# **Safety Evaluation Report**

related to the operation of  
**Diablo Canyon Nuclear Power Plant,**  
**Units 1 and 2**

Docket Nos. 50-275 and 50-323

Supplement No. 11

Figure 3-1 PG&amp;E's Implementing Organization

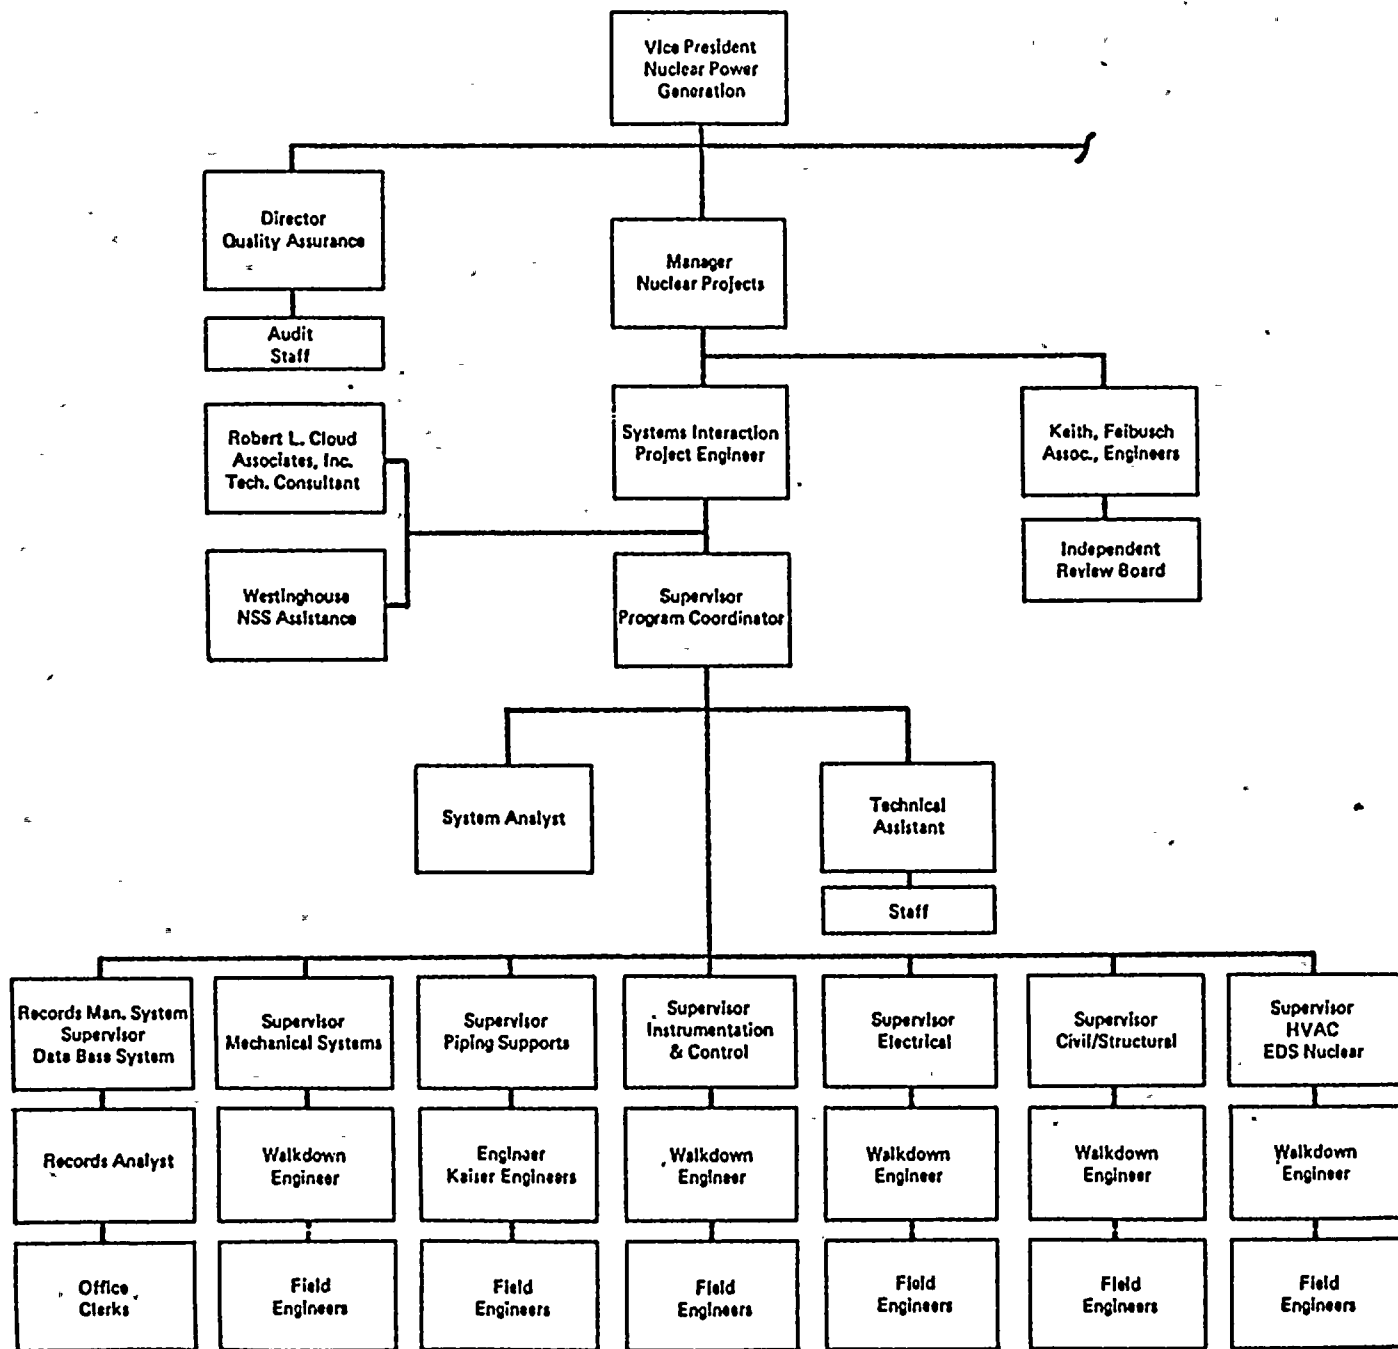
During the course of our review, we requested additional clarifying information concerning the composition, independence, and scope of review of the independent review team associated with PG&E's Quality Assurance Department and the Independent Review Board. At our request, PG&E revised their report to provide the requested clarifying information.

Our review of the organizational elements established by PG&E to implement their program, their responsibilities, and their reporting requirements has provided us with reasonable assurance that PG&E's program can be implemented in an acceptable manner. Therefore, we conclude that the organization established by PG&E to implement their program is acceptable.
